## DRAINAGE AND TRANSPORTATION INFORMATION SHEET (REV 09/2015)

**Re: CARMEL APARTMENTS B**  
**7330 Carmel Ave. NE**  
**Traffic Circulation Layout**  
Architect's Stamp03-03-2022(C19-069A)

Based upon the information provided in your submittal received 04-13-2022, the above referenced plan cannot be approved for Building Permit until the following comments are addressed:

AS-1.0

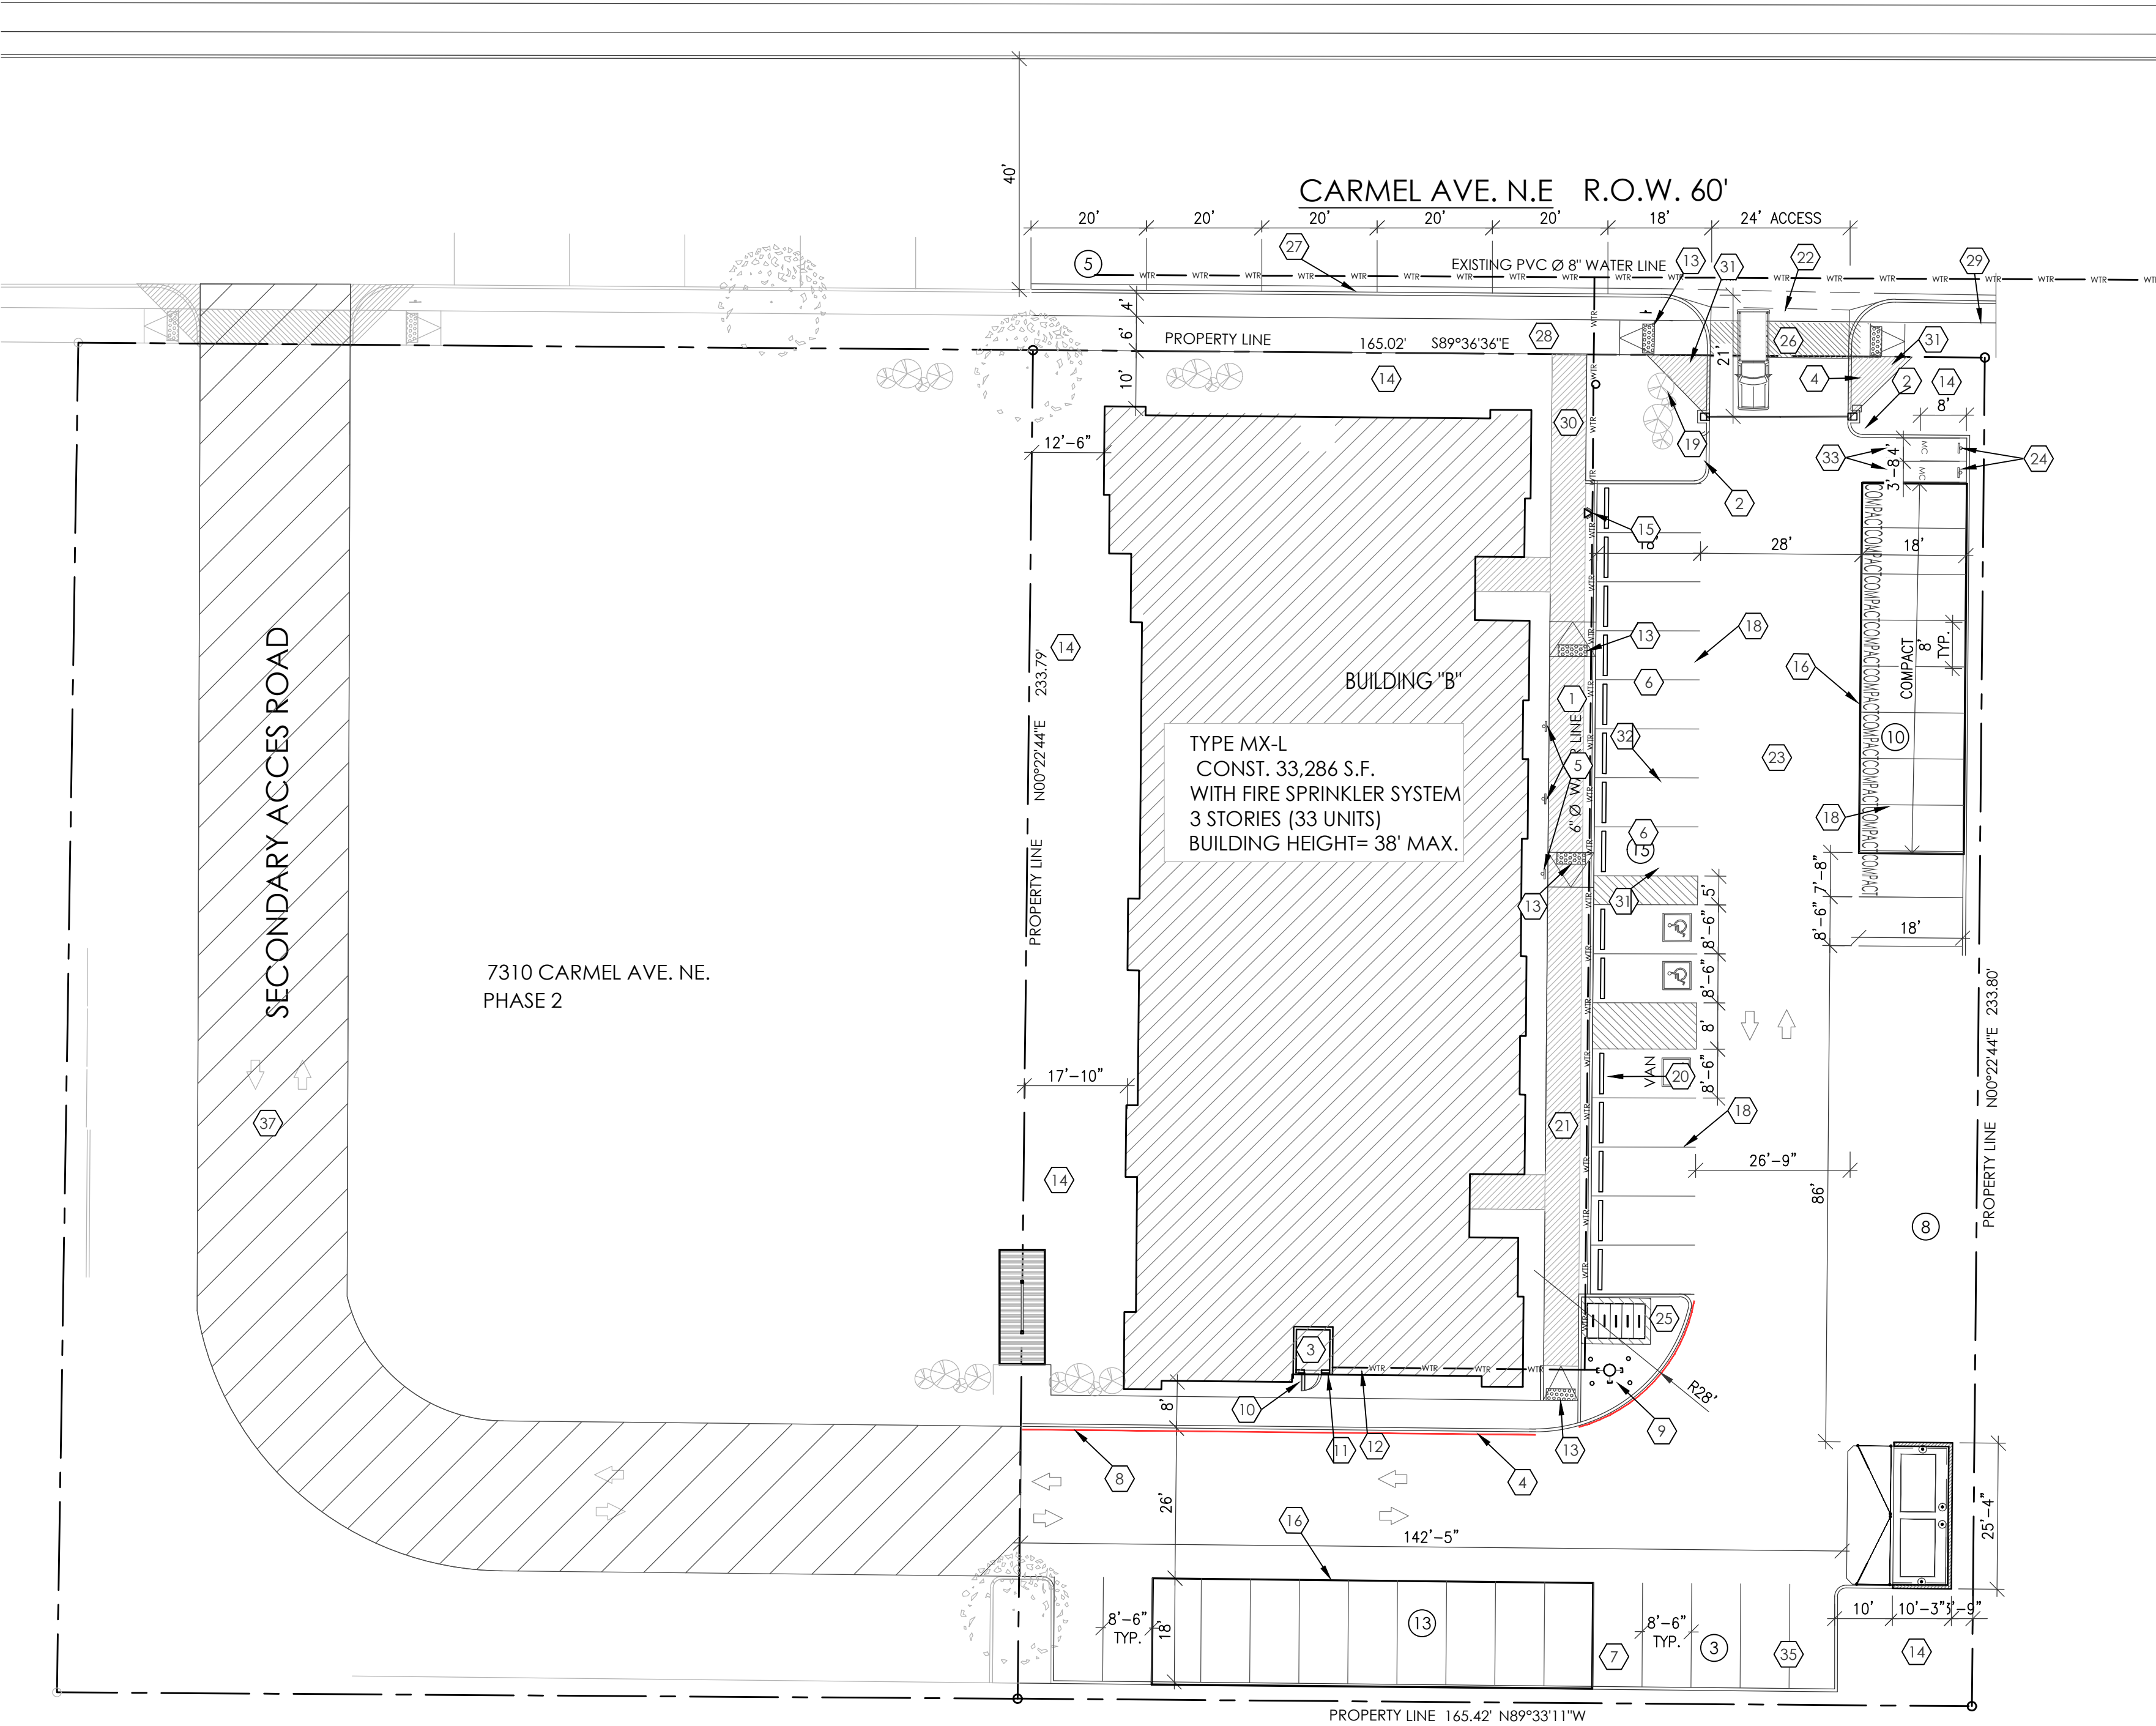
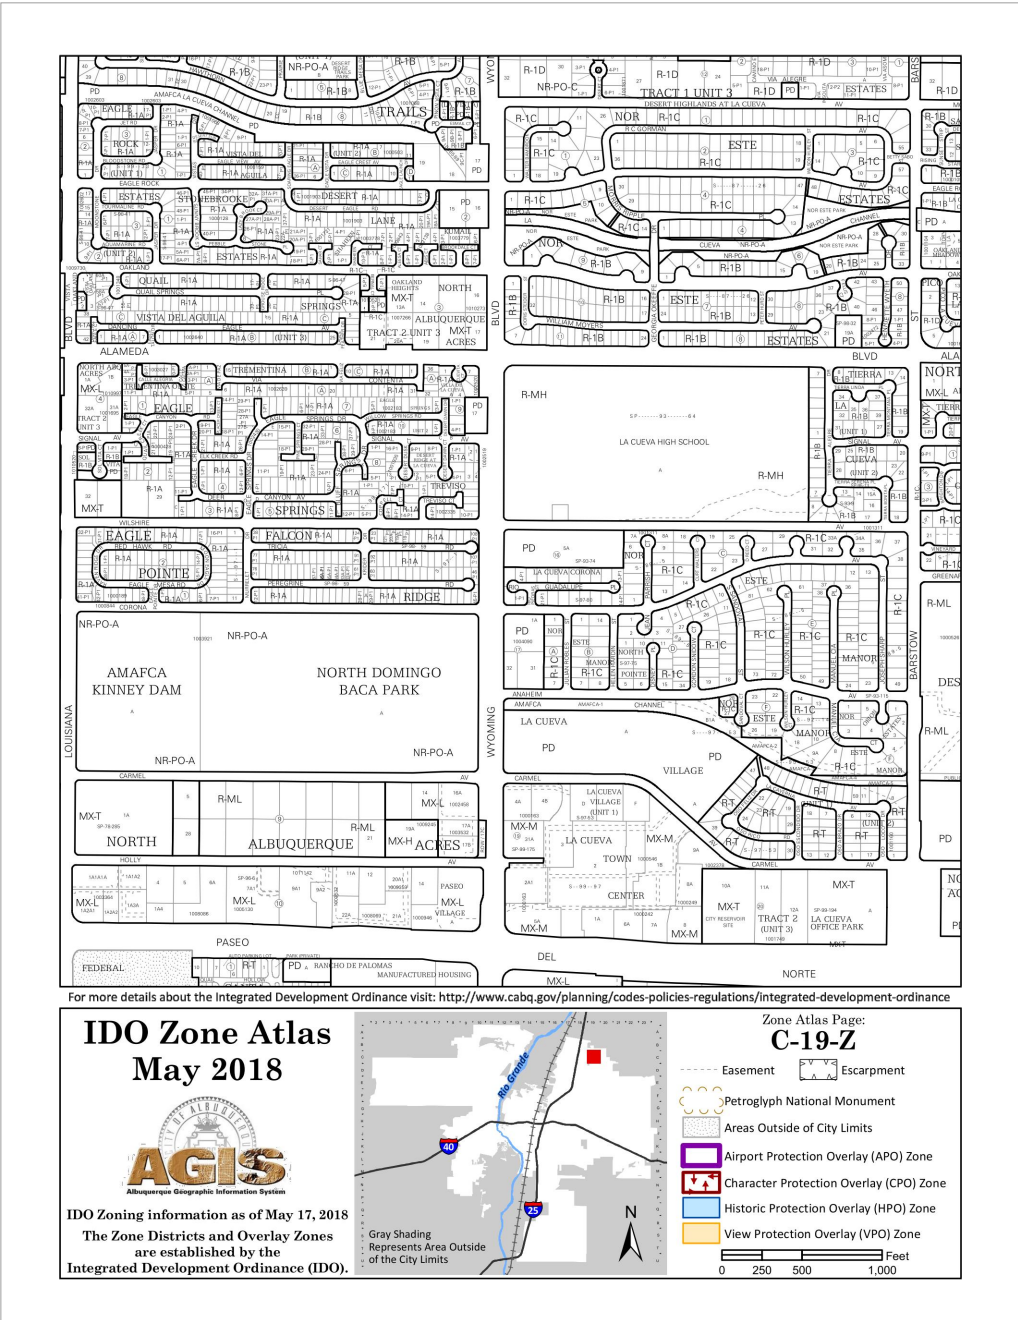
- **Keyed Note 22:** Change notation from drivepad to driveway and show the 6 ft valley gutter as part of the entrance drawing. **SEE UPDATED KEY NOTE**

- **Keyed Note 26:** Proposed cross pathway striping will need detail for striping. **SEE DETAIL A9/AS-2.0**
- **Keyed Note 28:** Provide a tie-in grade of 5:1 back to existing surface elevation at end of sidewalk. **SEE UPDATED KEY NOTE**

- **Keyed Note 29:** Reference COA std dwg 2430 for sidewalk detail and provide a tie-in grade of 5:1 back to existing surface elevation at end of sidewalk. **SEE UPDATED KEY NOTE**

- **Keyed Note 34:** Nope, remove this note. **KEY NOTE REMOVED**
- 3. An secondary emergency access will need to be provided as part of this proposed development and a temporary paved connection back to Carmel Ave will be needed as part of the TCL requirement. **SEE SECONDARY ROAD ON SITE PLAN**

- 4. **Keyed Note 1:** Reference A8/AS-2.0 instead of A10. **UPDATED**
- 5. **Keyed Note 13:** Reference either detail A8 or A10 on sheet AS-2.0 for proposed ramp.

- 6. **KEY NOTE REFERRED TO AS/AS2.0 DETAIL**
- 7. **Keyed Note 21 & 30:** Reference A5/AS-2.0. **KEY NOTE UPDATED**
- 8. **Detail A4:** Paint Bollards yellow. **DETAIL NOTE UPDATED**

- 9. **Detail AS:** Note 50:1 max on top of sidewalk and 12:1 max for taper. Stall widths are 8'-6" not 8'-0"-6" please adjust text. **DETAIL UPDATED**

- 10. **Detail A10:** 50:1 and 12:1 should have the word max. after each text. **DETAIL UPDATED**
- 11. **ADA Parking Access Aisle dimensions on site lan}**: You specify 8'-6" on layout but on detail you call out 8'-0". Please address this concern. **SITE PLAN DIMENSION UPDATED**

- 12. **Proposed Compact parking stalls:** Provide stall lengths for compact parking stalls. **see updated site plan**
- 13. You have a hatch area/segment of pavement around the drive aisle located at the corner back of the proposed building and no legend to define this hatching. Please provide some type of note to define this hatching. **See updated site plan**

- 14. Identify the right of way width medians, curb cuts, and **street width on** Carmel Ave. Clarify proposed property lines since an approved Plan was not provided. **SEE ATTACHED PLAT AND R.O.W. ON SITE PLAN**

18. Label the compact parking spaces by placing the words "**COMPACT**" on the pavement space. **SEE THE UPDATED SITE PLAN**
19. The ADA accessible spaces must include an access aisle. Van accessible aisles should be **8ft wide**; all others should be 5ft wide. **SHOWED ON SITE PLAN**

20. **Motorcycle parking spaces:** Provide stall widths. **SHOWED ON SITE PLAN**
21. Provide a copy of refuse approval. **ATTACHED TO THIS EMAIL**
22. Fire Department: An approval Fire 1 plan needs to be provided. **ATTACHED TO THIS EMAIL**

**THE PROPERTIES BELONGS TO THE SAME OWNER**
25. Add a note stating "All broken or cracked sidewalk must be replaced with sidewalk and curb & gutter." A build note must be provided referring to the appropriate City Standard drawing (2430 & 2415A). **NOTE ADDED TO SITE PLAN**

KEYED NOTES
1. 6' x 6' LANDING WITH ACCESSIBLE CURB RAMP, REF: DETAIL A8/AS-2.0.
2. 2'-0" CURB RADIUS, TYP., CURB PER C.O.A. STANDARD DWG. 2415A.

19. PIV LOCATION.
20. CONCRETE WHEEL STOP, TYP.
21. 4" THICK CONCRETE SIDEWALK, TYP. REFERENCE DETAIL A5/AS-2.0.
22. CONSTRUCT NEW CONCRETE DRIVEWAY PER C.O.A. STANDARD DWG 2426 (WITH PARALEL RAMP) WITH 6' VALLEY GUTTER PER C.O.A. STANDARD DWG 2420, REF: GRADING AND DRAINAGE PLAN.

G. THE RACKS SHOULD BE STURDY AND ANCHORED TO A CONCRETE PAD.
26. 6' WIDE ACCESSIBLE PEDESTRIAN PATH, TYP. REF: DETAIL A9/AS-2.0
27. CONSTRUCT NEW RAISED 8" STD CONCRETE CURB AND GUTTER PER C.O.A. STANDARD DRAWING 2415A.

28. CONSTRUCT NEW 6' WIDTH CONCRETE SIDEWALK PER C.O.A. STANDARD DWG. 2430, MATCHING EXISTING SIDEWALK (5:1 TAPER PROVIDED AT END OF SIDEWALK, IF NECESSARY).

29. START OF 6' CONCRETE SIDEWALK, PER C.O.A. STANDARD DWG. 2430 (5:1 TAPPER PROVIDE IF NECESSARY).
30. 6 FT WIDE ADA ACCESSIBLE PEDESTRIAN PATHWAY (HATCHED AREA ONLY ON PLANS). REFERENCE DETAIL A5/AS-2.0

34. NOT USED.
35. CONTAINER FOR RECYCLING.
36. PAINTED "COMPACT" - WHITE ON PAVEMENT PER CABQ STANDARDS. WHERE IS SHOWN ON PLANS.
37. SECONDARY ACCESS ROAD.

ALL BROKEN OR CRACKED SIDEWALK MUST BE REPLACED WITH SIDEWALK AND CURB & GUTTER BY ACCORDING TO THE APPROPRIATE CITY STANDARD DRAWING.

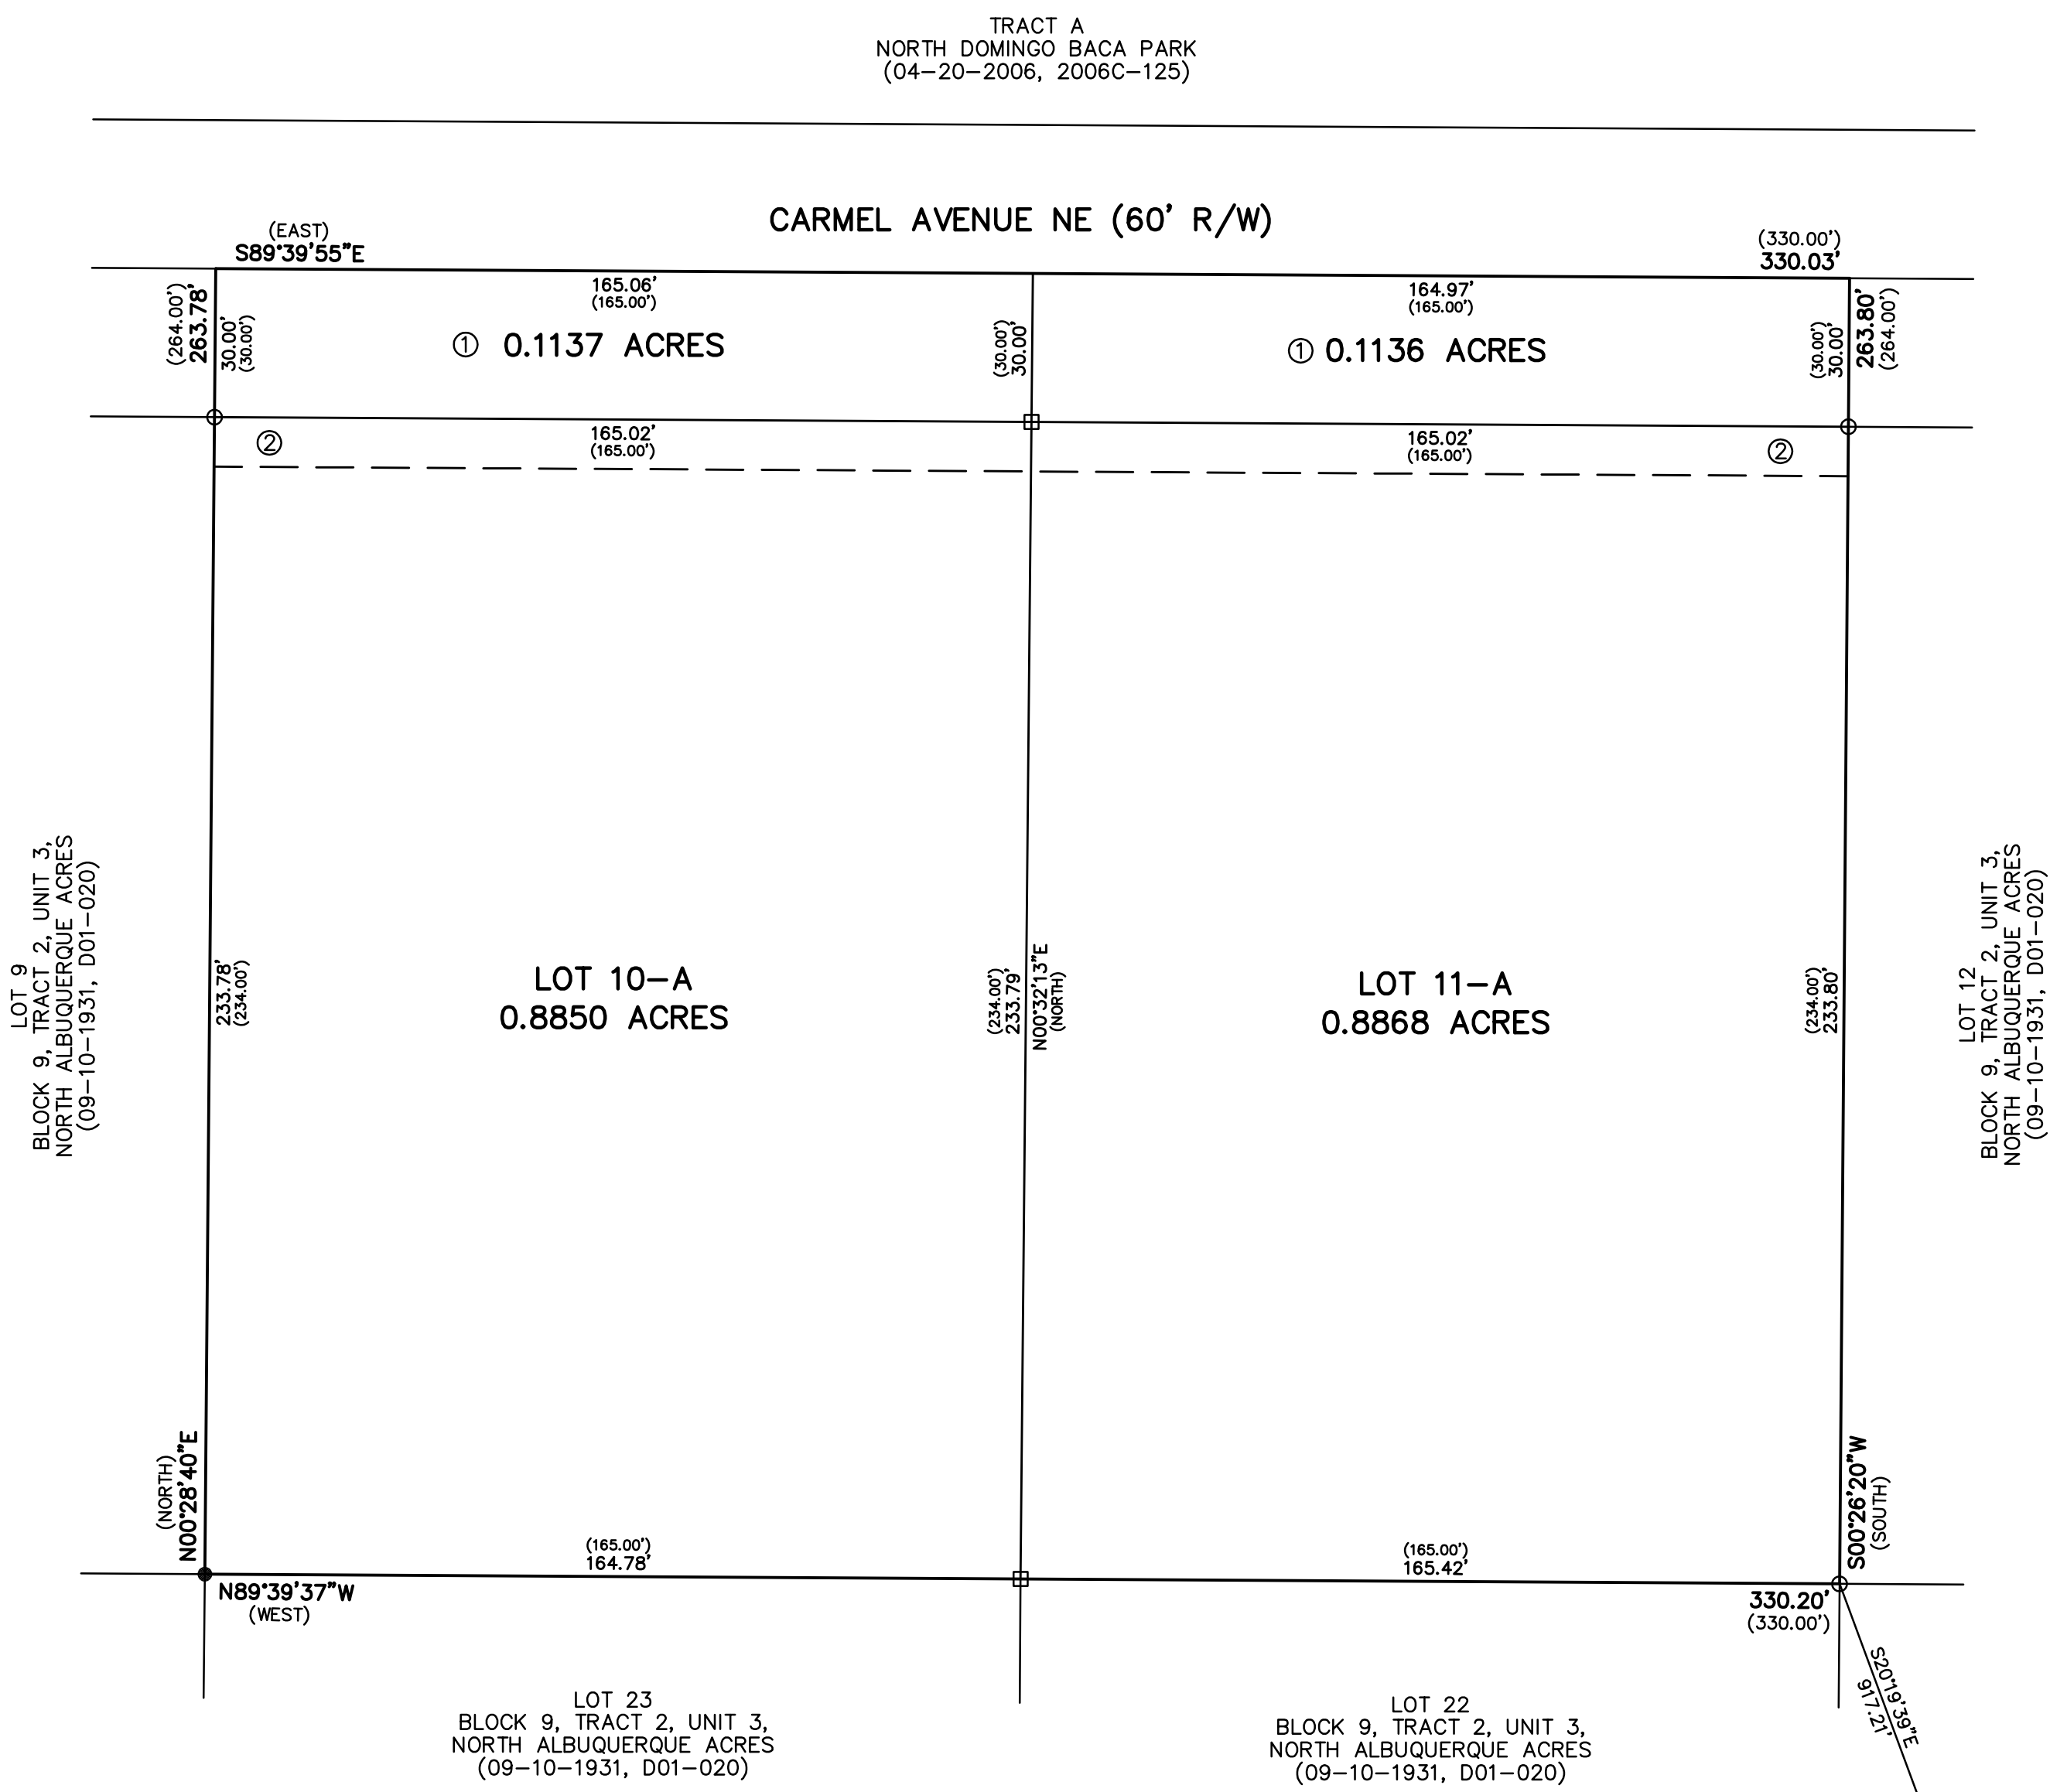
- How was the curblin/setback requirements determined without an approved Plat (Not provided)?
- An approved Plat will need to be provided.
- What is the status on the missing portion of Carmel Ave Roadway Infrastructure? You will need to provide an infrastructure list and/or financial guarantee (DRB action required).

- From above, pick which one will apply to this concern of Carmel's missing roadway portion. **PLEASE SEE ATTACHED PLAT**
- It appears that you are proposing onstreet parking. Please coordinate with Traffic Operations on the striping or remove striping. You will need a **clear site line exhibit** since onstreet parking is being proposed and might possibly block stopping site distance.

You will need an approved Plat (ORB action required).

- EASEMENTS/RIGHT-OF-WAY
- ① EXISTING ROADWAY AND UTILITY EASEMENT  
(09-10-1931, D01-020) (0.2273 ACRES)  
(DEDICATED TO THE CITY OF ALBUQUERQUE BY THIS PLAT)
  - ② 10' PUBLIC UTILITY EASEMENT (PUE)  
(GRANTED BY THIS PLAT)
